Access Compliance Report Public Rights-of-Way (Curb Ramps)

Main Street: STONYBROOK_DR Cross Street: S_GILBERT_ST Location: NW

ADA ID: RPRK210927142914 Ramp Type: Type 1 - Perpendicular Diagonal Initial Pass/Fail: Fail Overall Compliance: No Severity Score: 16

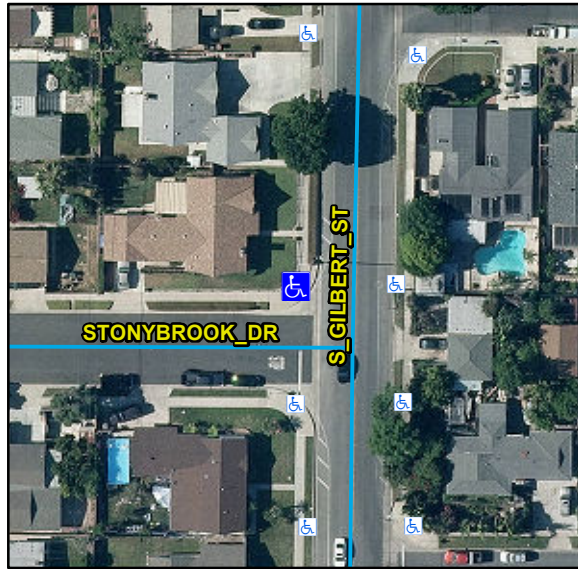
R304.2.2, R204.3, R304.5.3, STD 1115

Remove & Replace Curb Ramp With Two New Directional Ramps or Equivalent.
